## **ADDENDUM NO. 4**

CITY OF SAN ANTONIO  
CAPITAL IMPROVEMENTS MANAGEMENT SERVICES

PROJECT NAME: **Market Street Realignment**

PROJECT NO.: **40-00300**

MARKET STREET REALIGNMENT  
 WEST FRONTAGE ROAD  
**REMOVAL LAYOUT**  
 STA 23+20 TO STA 25+40

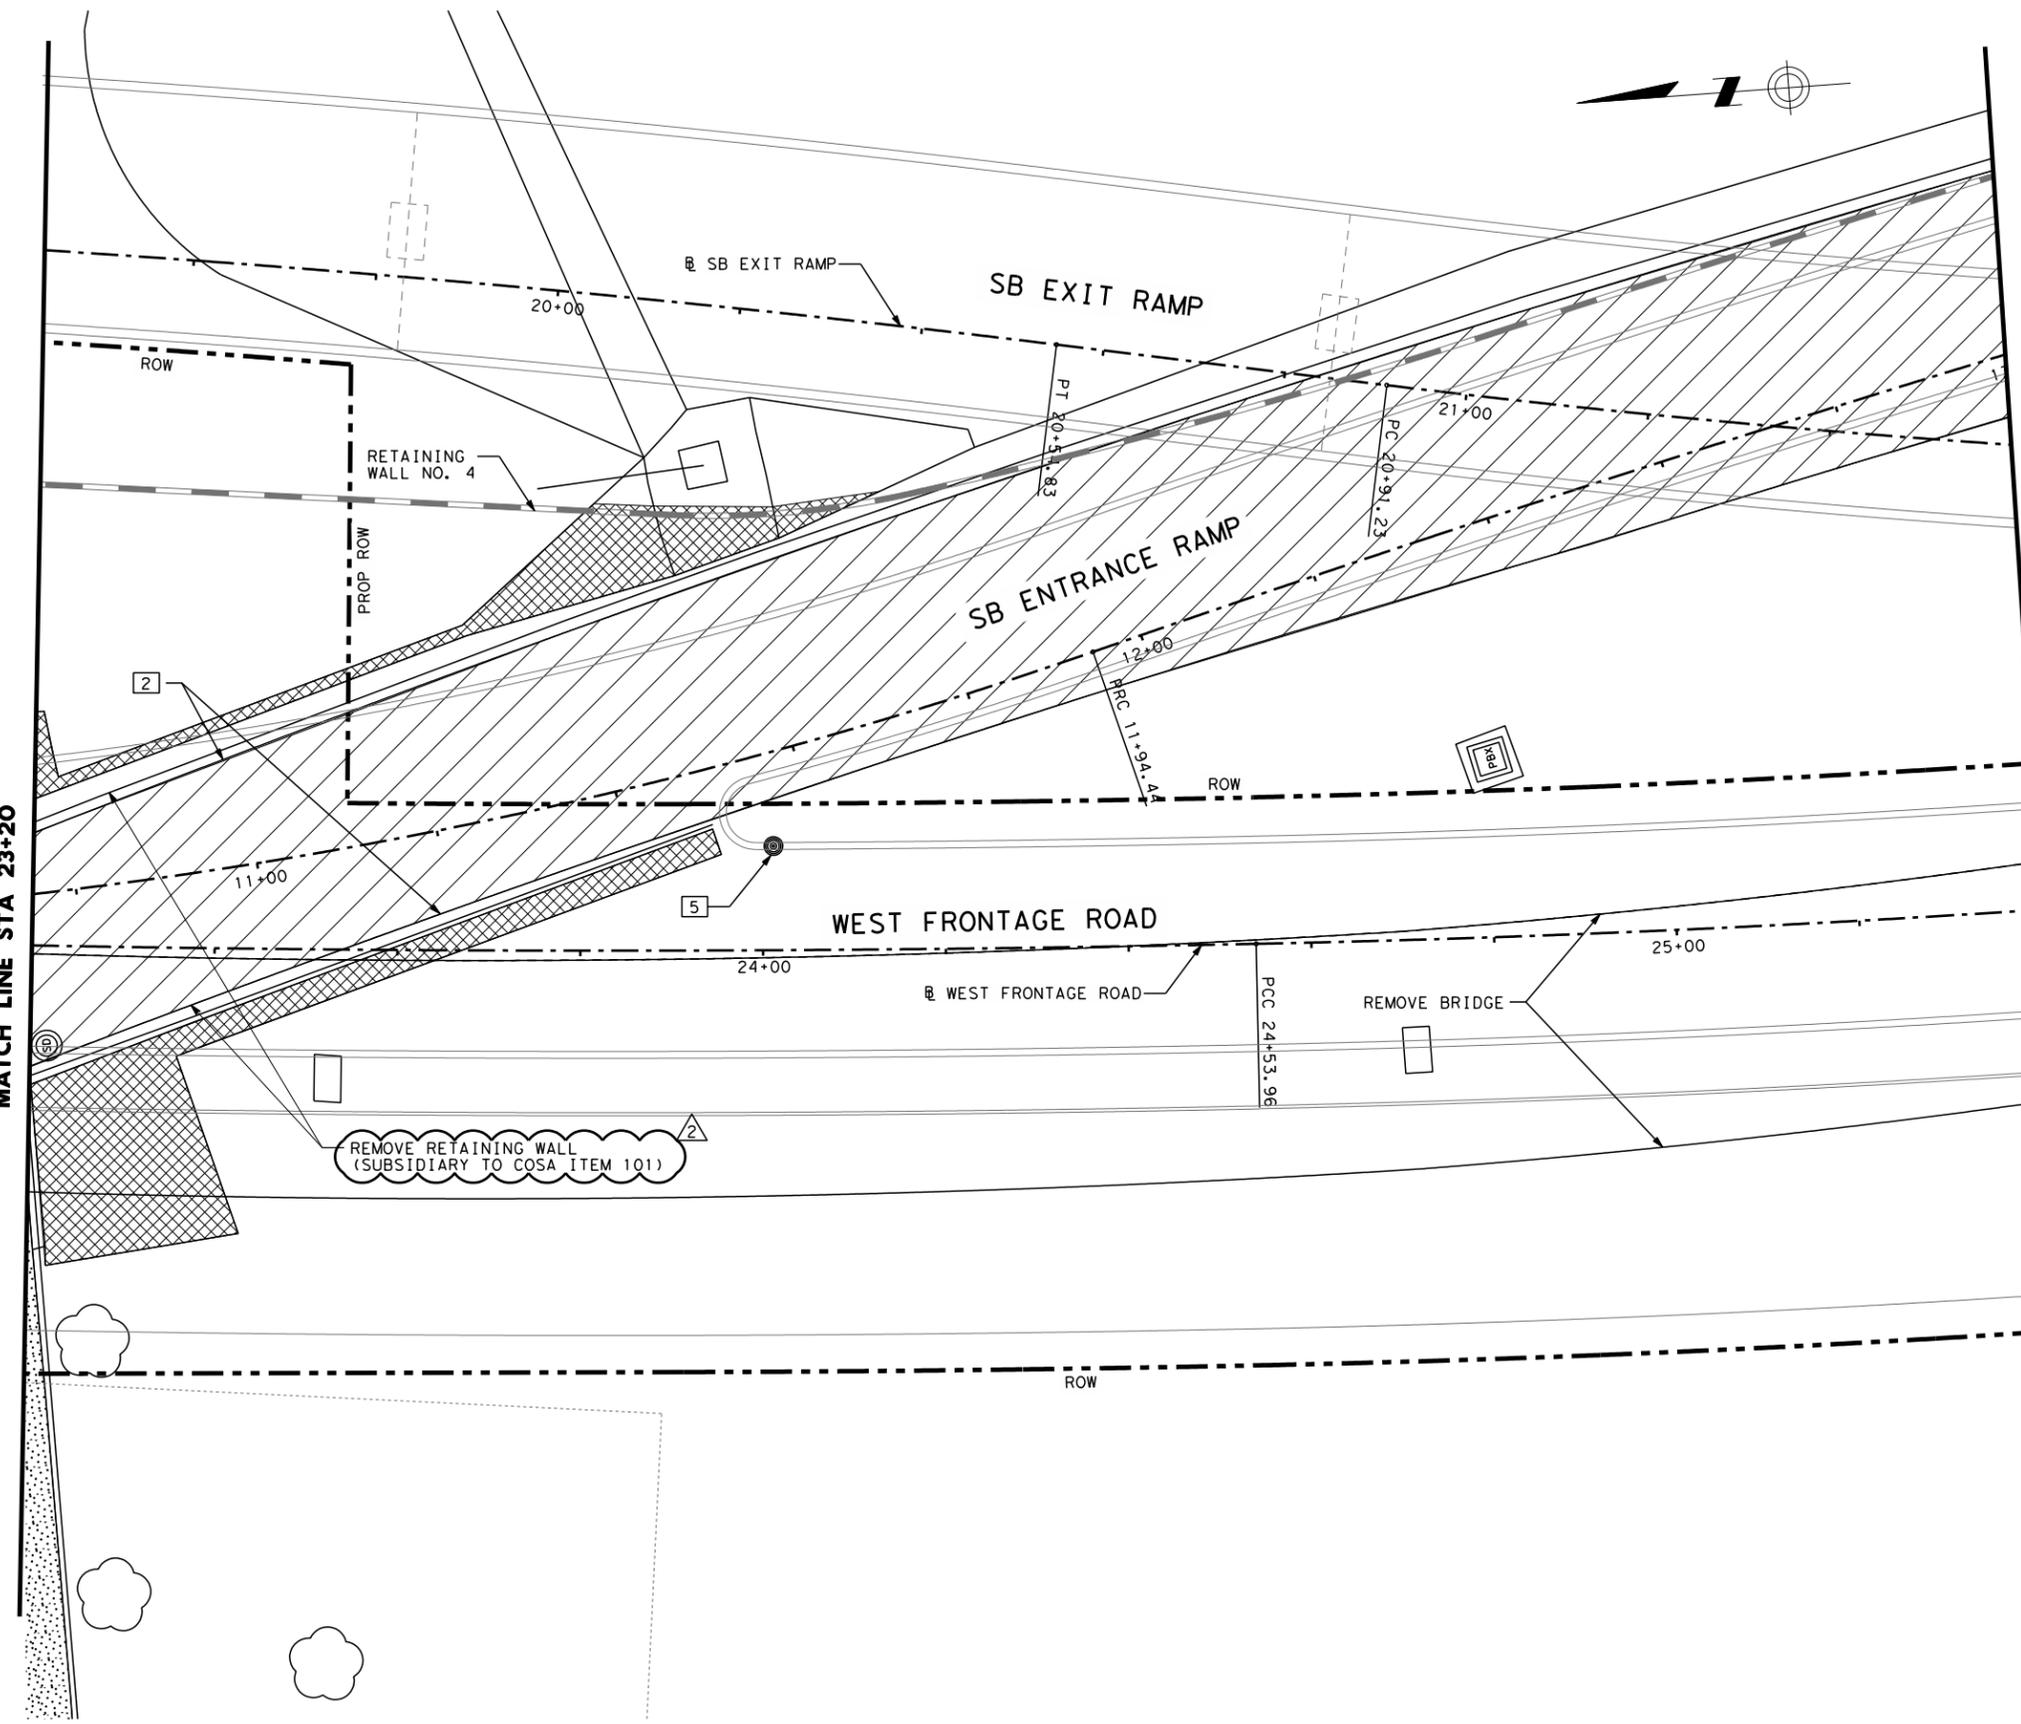
9. Q: There is no removal item to cover the removal of the MSE walls at the pedestrian bridge. Please clarify.  
A: The removal of the MSE retaining walls at the pedestrian bridge is subsidiary to CoSA Item 101, Preparing Right-of-Way. This will be clarified on sheets 145 and 146 in Addendum No. 4.

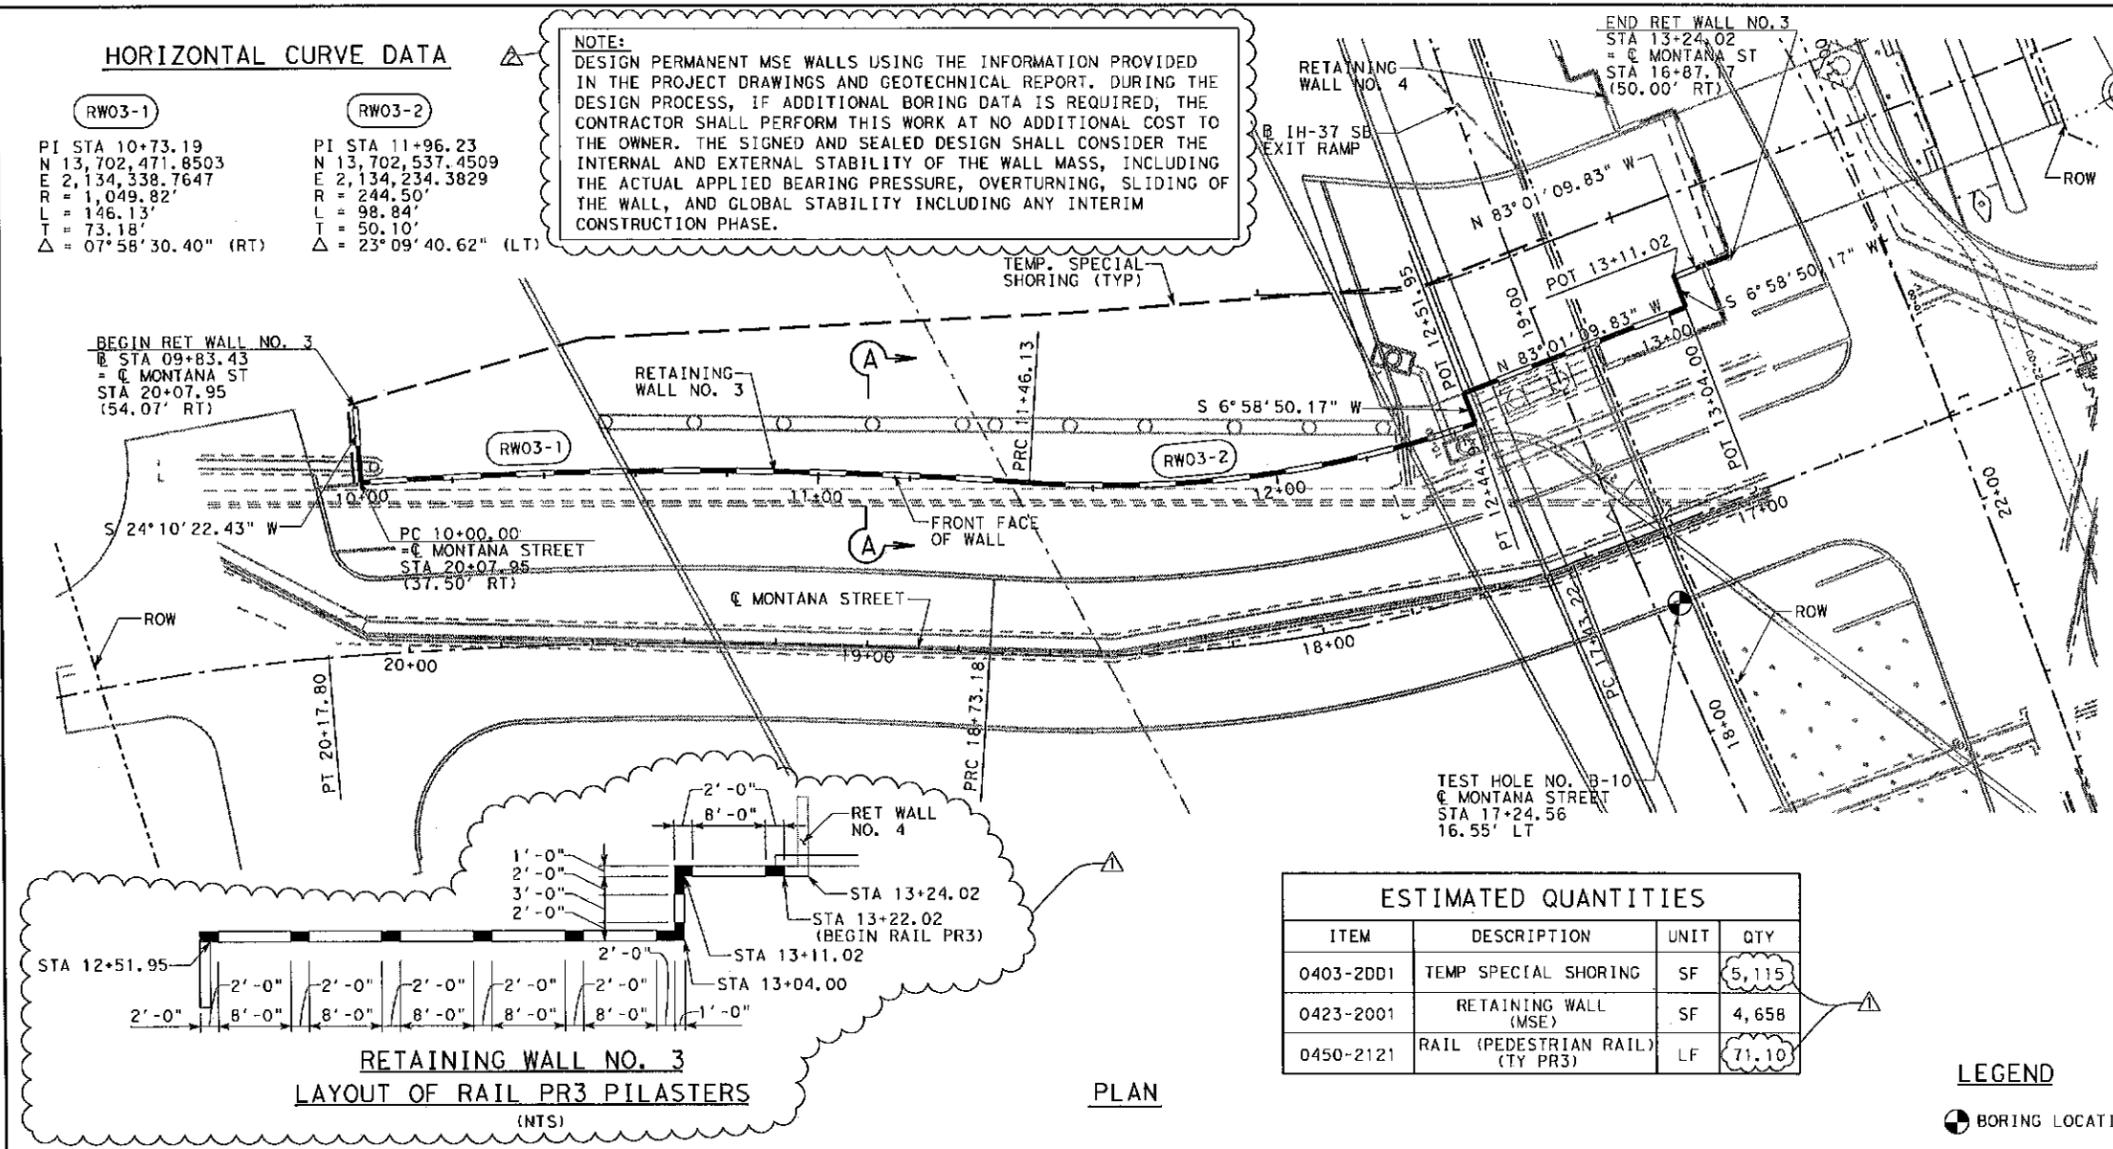
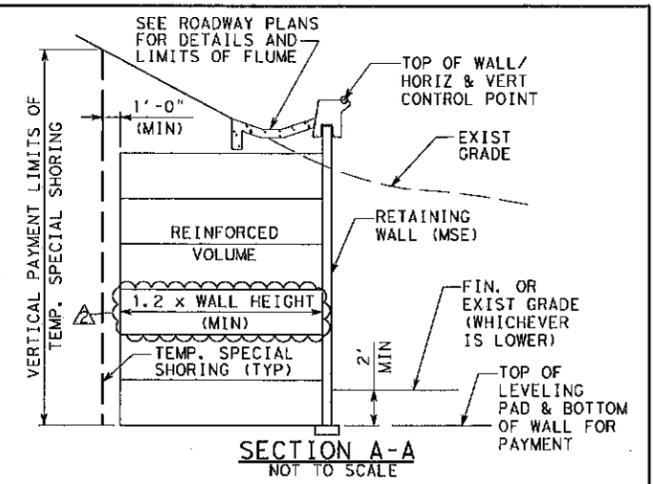
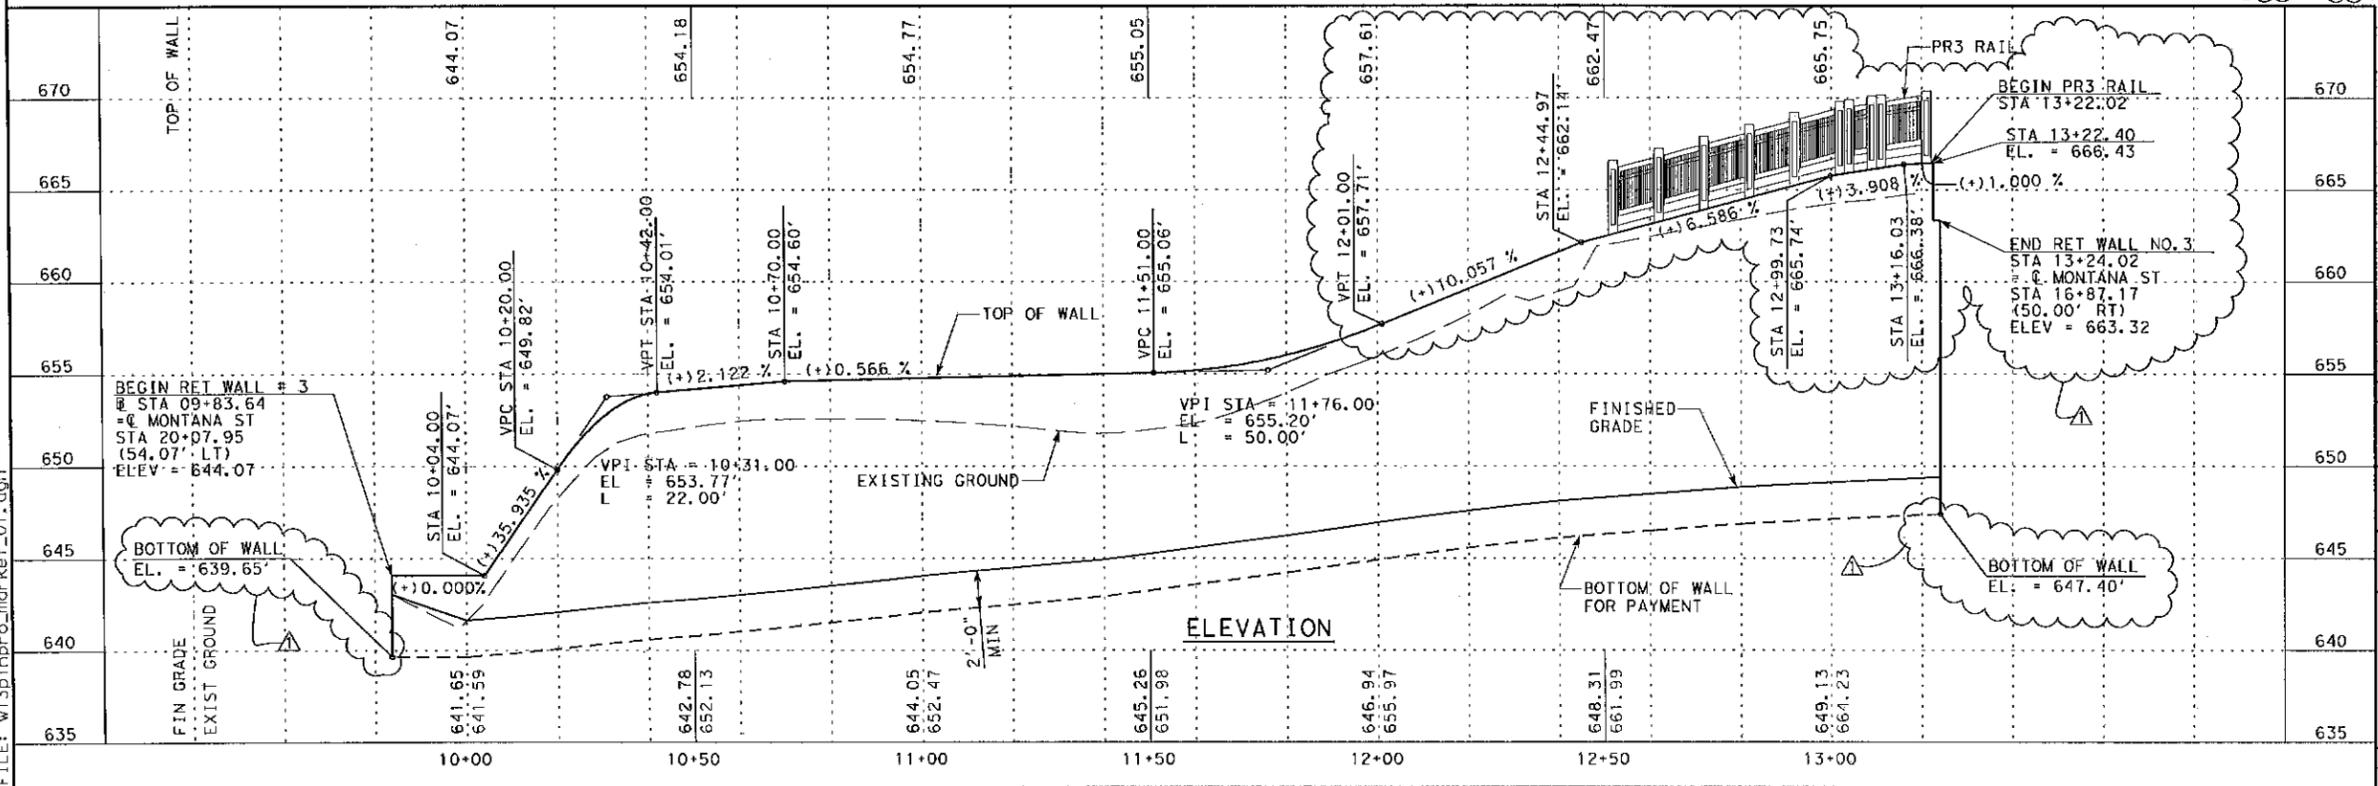
NO.	REVISION	DATE	APPROVED
1	ADDED NOTES & MIN. LENGTH OF EARTH REINF	2/8/13	JAB
2	ADDENDUM NO. 2	1/18/13	NMB

**NOTE:**  
 DESIGN PERMANENT MSE WALLS USING THE INFORMATION PROVIDED IN THE PROJECT DRAWINGS AND GEOTECHNICAL REPORT. DURING THE DESIGN PROCESS, IF ADDITIONAL BORING DATA IS REQUIRED, THE CONTRACTOR SHALL PERFORM THIS WORK AT NO ADDITIONAL COST TO THE OWNER. THE SIGNED AND SEALED DESIGN SHALL CONSIDER THE INTERNAL AND EXTERNAL STABILITY OF THE WALL MASS, INCLUDING THE ACTUAL APPLIED BEARING PRESSURE, OVERTURNING, SLIDING OF THE WALL, AND GLOBAL STABILITY INCLUDING ANY INTERIM CONSTRUCTION PHASE.
